Final Environmental Impact Statement (EIS)
Kapaa Refuse Transfer Station (March 1988)
City and County of Honolulu
Department of Public Works, Refuse Division
Tax Map Key: 4-2-15: 05

DEPARTMENT OF LAND UTILIZATION (DLU)
87/EIS-11(BWM)
April 27, 1988

ACCEPTANCE REPORT: KAPAA REFUSE TRANSFER STATION
CHAPTER 343, HRS
FINAL ENVIRONMENTAL IMPACT STATEMENT (EIS)
KAPAA, KAILUA, OAHU
CITY AND COUNTY OF HONOLULU
DEPARTMENT OF PUBLIC WORKS
TAX MAP KEY: 4-2-15: 05

Figure 5
Development Plan
Public Facilities Map

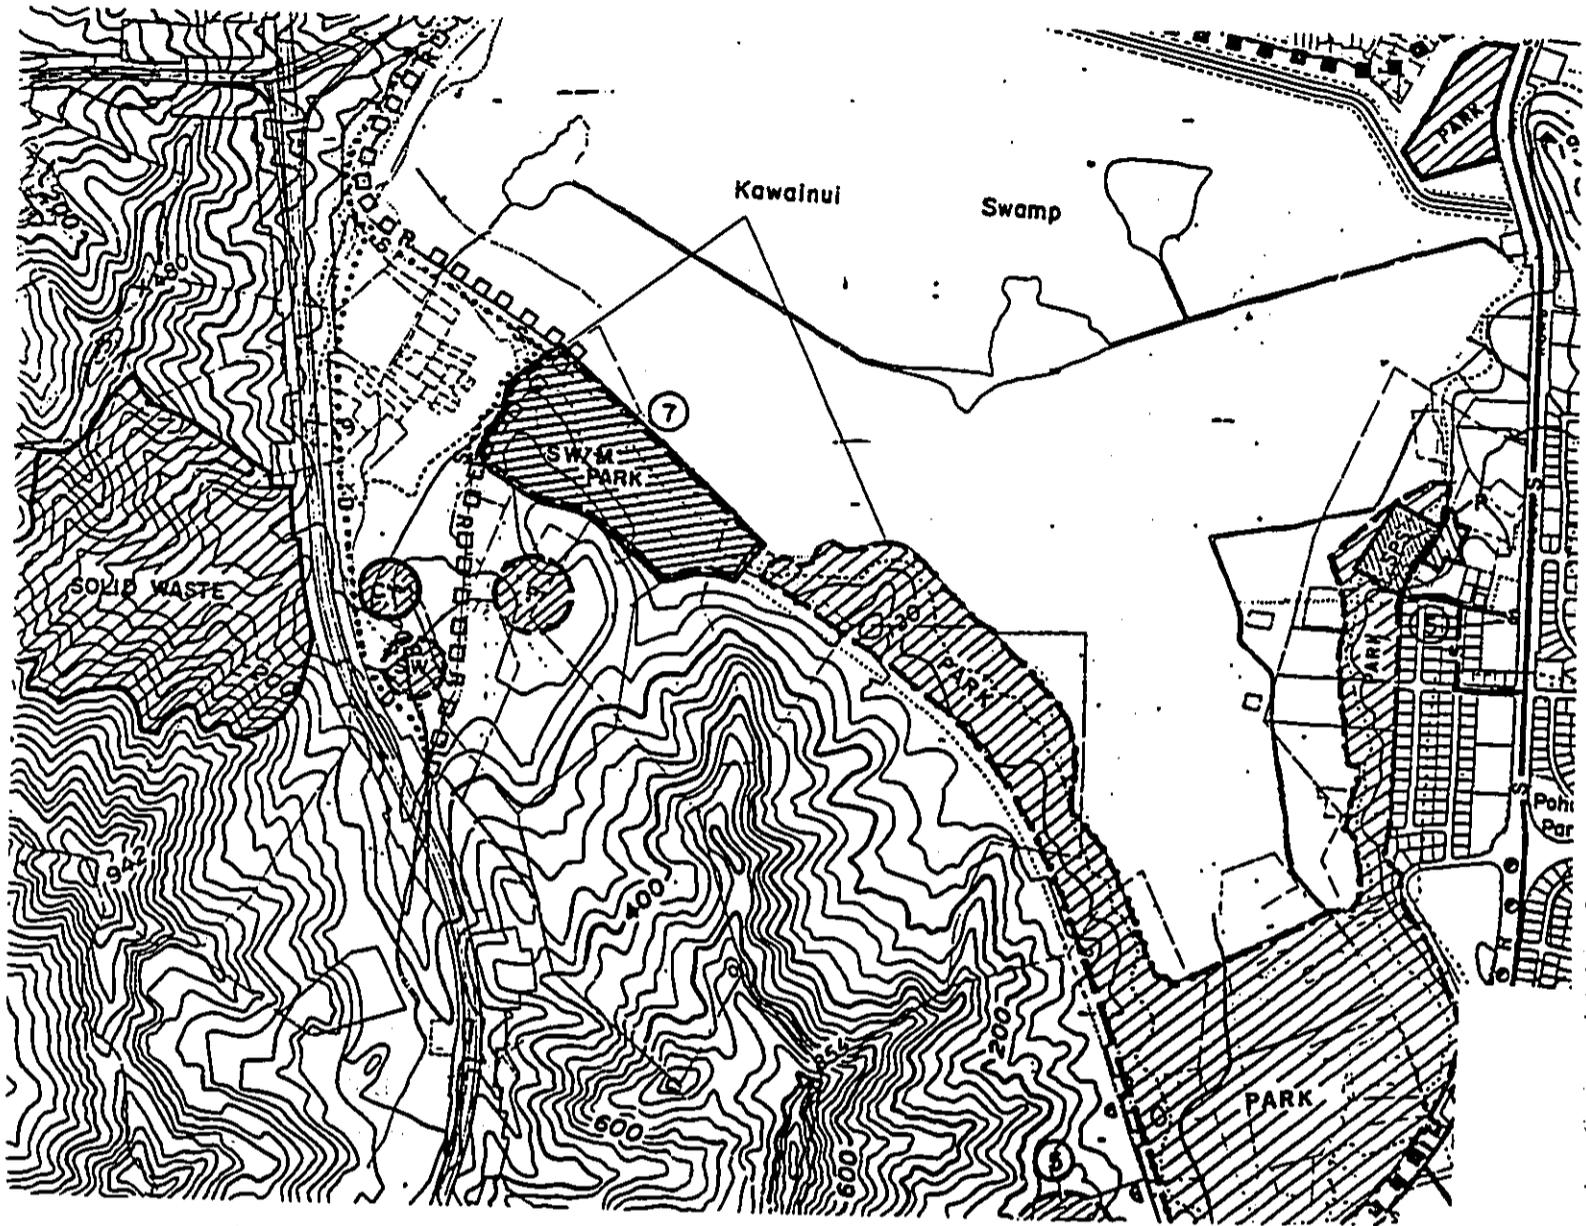
b. Figure 5, "Development Plan Public Facilities Map" was corrected.

- 4. City Development Plan**
 - a.** Figure 5 is not the City Development Plan Public Facilities (DP-PF) map. A copy of the pertinent section of the DP-PF map is attached. (Attachment A)

- a. We will replace the DP-PF map with the provided Attachment A (Figure 5).
- b. The DGP language as provided in Attachment E will be incorporated into the Final EIS.
